# UNITED STATES PATENT AND TRADEMARK OFFICE

Application Number: 10/840,056  
Filing Date: May 05, 2004  
Appellant(s): CHIEN ET AL.

**EXAMINER'S ANSWER**

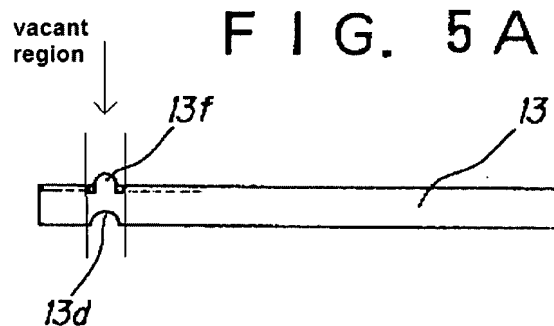
Claims 1-3, 7-14 and 18-19 are rejected under 35 U.S.C. 102(b) as being anticipated by Ito (Figures 5A, 6 and 9). Figures 6 and 9 of Ito discloses a cooling fin 18, 19 having a heat radiation part and a bonding part bent and brazed to a substrate 12 (Figure 2), where the bonding part has a “vacant region” 18g, 19g.

Regarding claims 2-3 and 14, Figures 6 and 9 of Ito discloses notches 18g and 19g, respectively, which is read as defining a “serrate edge.”

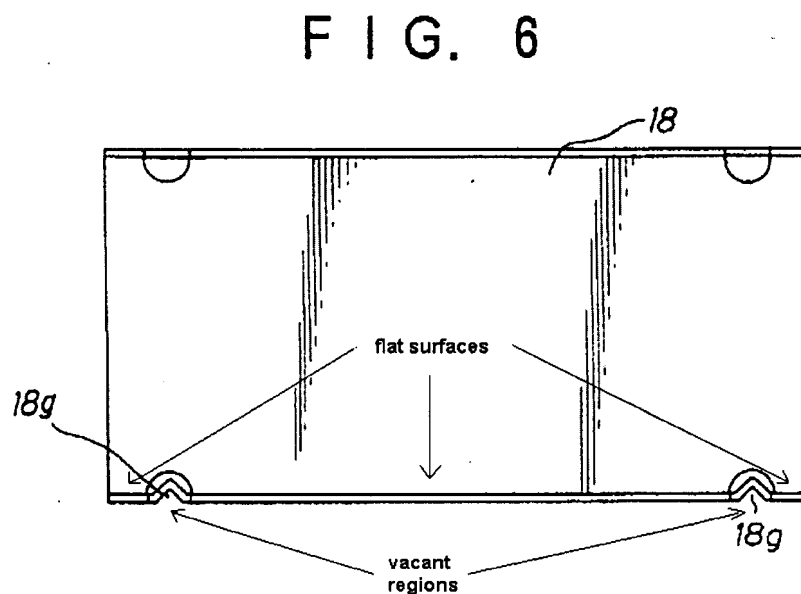
Appellant's remarks with respect to the rejection of claim 1 are not commensurate in scope with the claim. Figures 6 and 9 (column 6, lines 27-41 and column 7, lines 12-19) of Ito disclose concave sections 18g, 19g *coinciding* with "vacant regions" in the flat surface of the bonding part in the space provided on the line in Figure 5A (as shown below).

Note, the concave sections 18g, 19g are *not* in the plane of the flat surface of the bonding part.

Only the vacant regions are in the plane of the flat surface of the bonding part as shown below.

FIG. 2

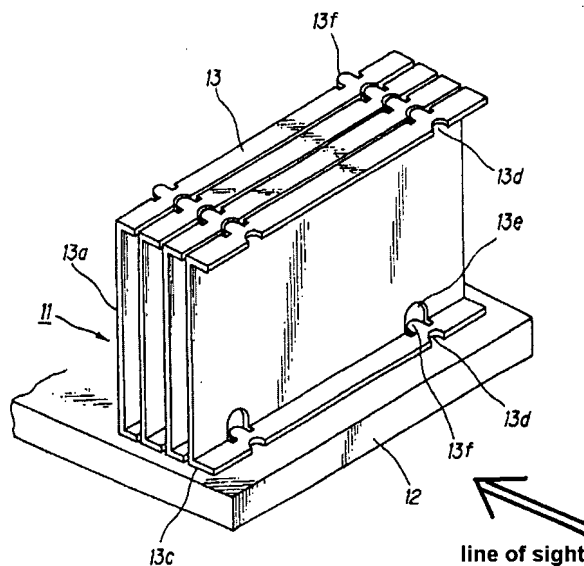
Appellant’s remarks with respect to the rejection of claim 11 are not commensurate in scope with the claim. The claim does not recite the perspective of the vacant region that is not covered. As shown below, in the perspective taken in the direction of the arrow in Figure 2 and into the plane of the sheet of Figure 6 and 9, the vacant region is not covered, in that an unobstructed line of sight extends between the substrate 12 and the concave sections 18g, 19g prior to any collection of braze solder.
